To: Kristopher Byrd, Well Construction and Compliance Section Manager
From: Travis Kelly, Well Construction Program Coordinator
Subject: Review of Water Right Application G-19001
Date: December 11, 2020

Application # G- 19001

TO: Water Rights Section Date 12/9/2020
 FROM: Groundwater Section Travis Brown
Reviewer's Name
 SUBJECT: Application G- 19001 Supersedes review of _____
Date of Review(s)

A. GENERAL INFORMATION: Applicant's Name: Merle and Grace Stutzman County: MARION

Well Location Map

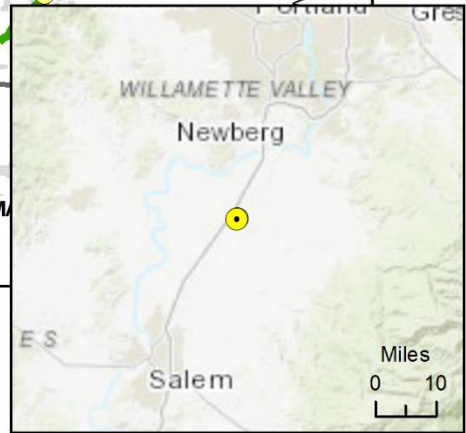
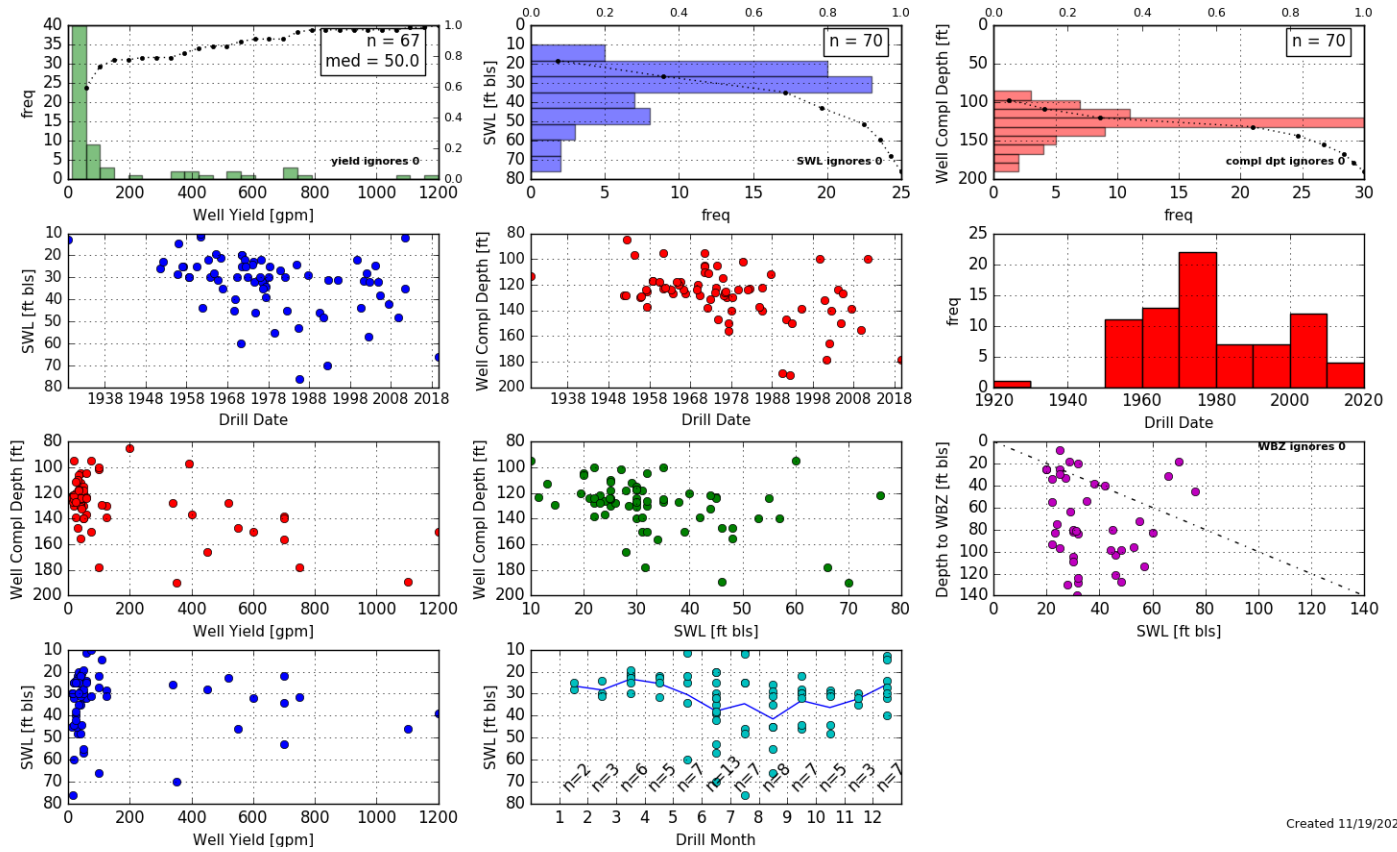
The nearest neighboring well to the proposed POA appears to be MARI 906, ~270 ft northeast of proposed POA 2 and ~380 ft northwest of POA 1 (see Well Location Map, attached). However, several residences presumed to be served by exempt domestic wells are closer than MARI 906 to the proposed POA. Regardless, given the low requested rate (0.15 cfs), the proposed use is not anticipated to cause interference with neighboring wells sufficient to meet the definition of injury.

Hydrographs – all measurements

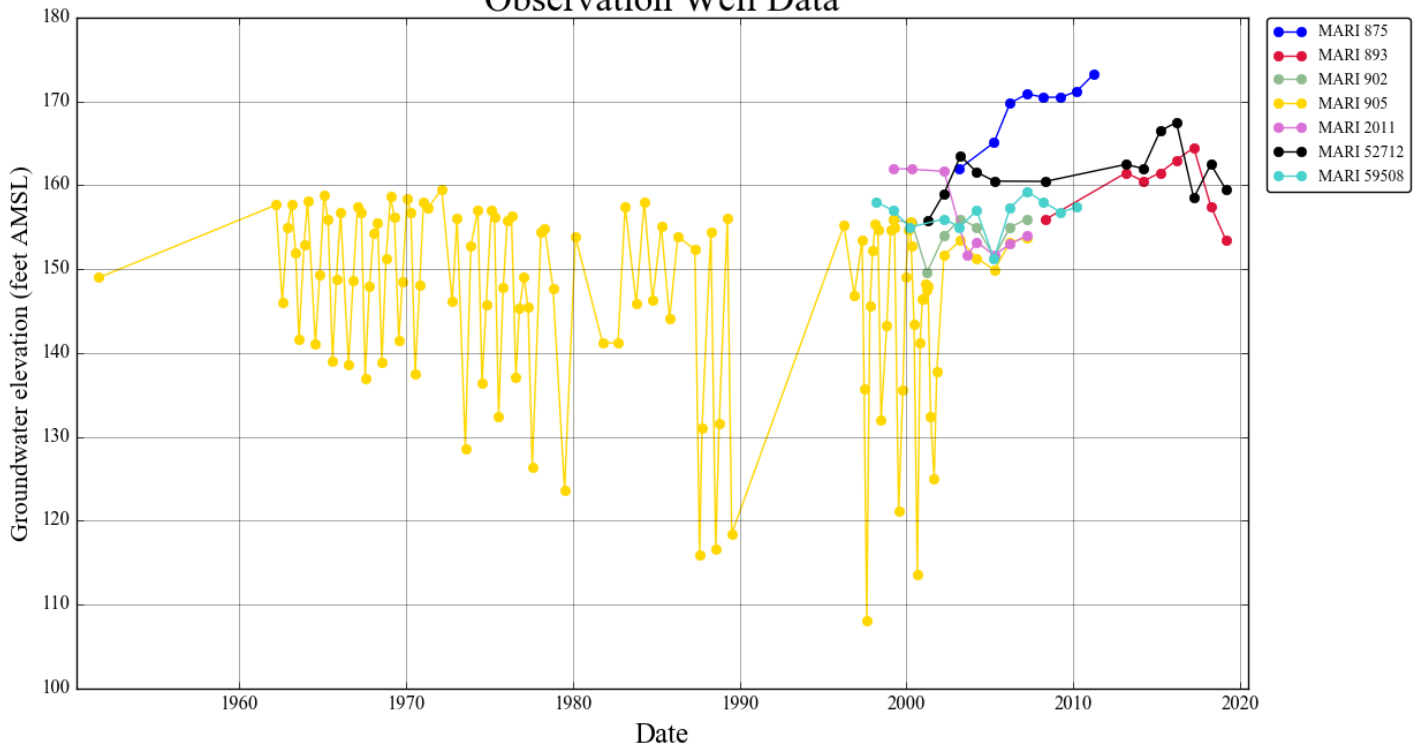
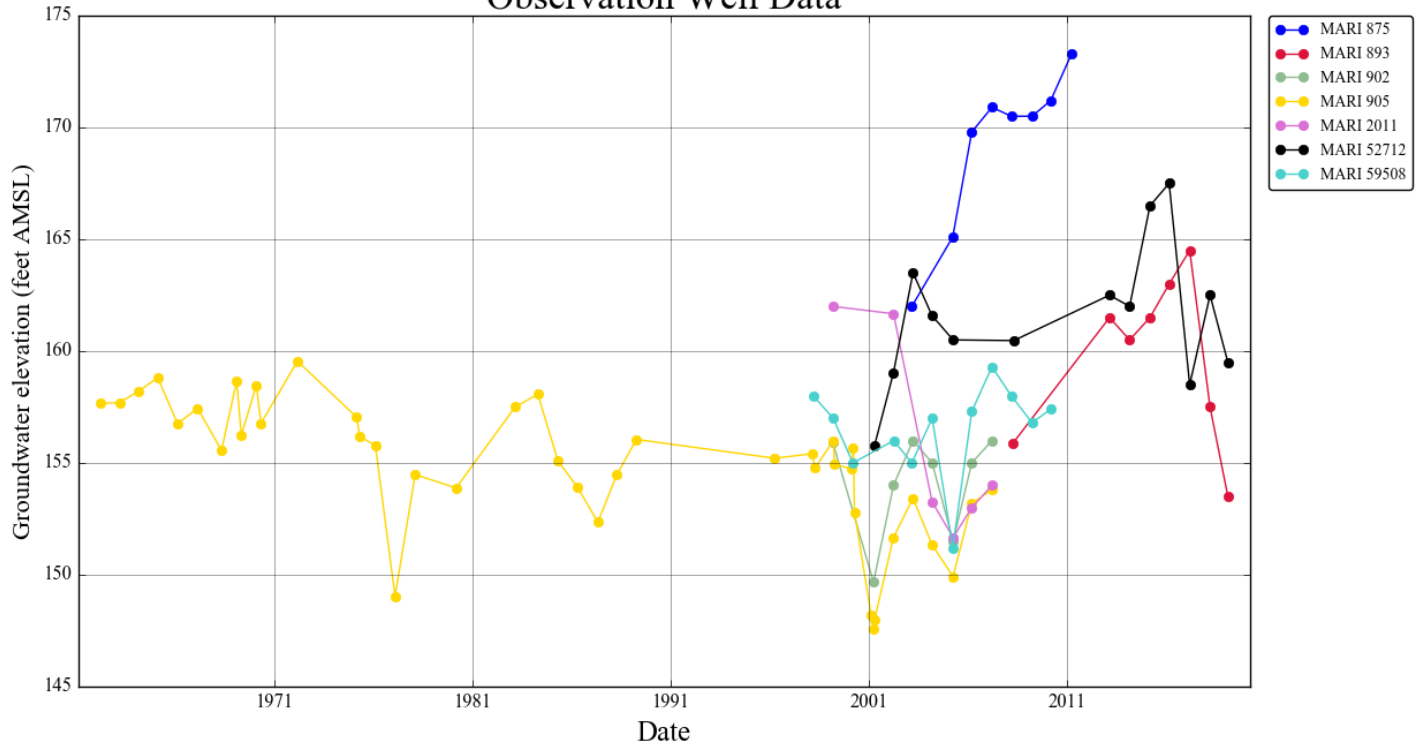
The proposed POA will produce from ~20-40 ft of sand and gravel (the Willamette aquifer) which occur beneath ~80-100 ft of fine-grained sediments (the Willamette Silt) (Gannett and Caldwell, 1998). The requested rate (0.15 cfs) is well within the range of reported yields for water wells in this area (see attached Well Statistics). Static water levels are typically 15-35 ft bls in this area of the Willamette aquifer, though seasonal water level fluctuations in the shallow alluvium are typically 50-60 ft per year (see attached Hydrographs). Despite the substantial fluctuation in water level, which is expected to grow as groundwater use increases in this area, and the relatively shallow total depths of the proposed POA, the low requested rate should mean that there will be sufficient available head for the proposed use. Nearby hydrographs do not indicate progressive, area-wide declines (see attached Hydrographs).
